RE: 35 Barn Field - Structural Inspection Report

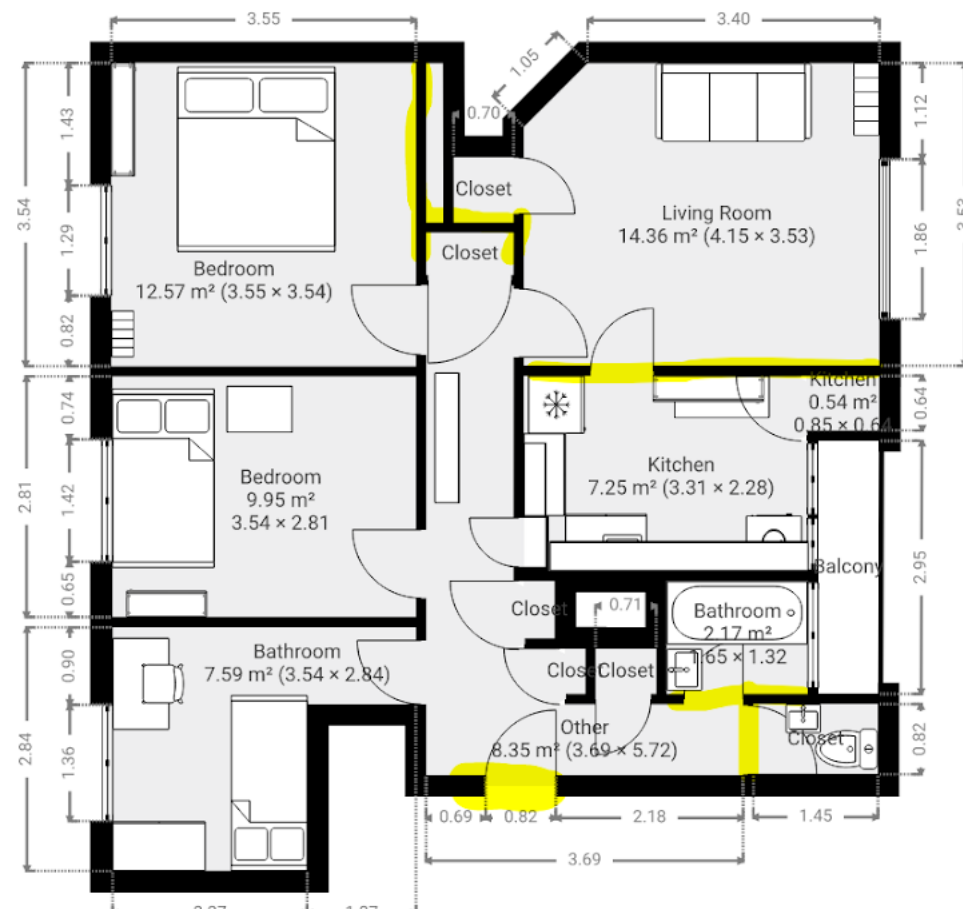
I have reviewed the updated proposed layout and our issued report and photos taken during the site visit. I understand from the below and the proposed layout that the walls highlighted in yellow below are proposed to be demolished? Would you also be planning to demolish the existing downstand above the toilet (in the attached photo)?

In order to confirm whether these walls are loadbearing or not prior to removal, I would recommend the contractor open up the finishes locally at the top of the wall / ceiling joint at each and every wall/downstand location that is to be demolished. I have provided an example marked up photo below for one of the walls.
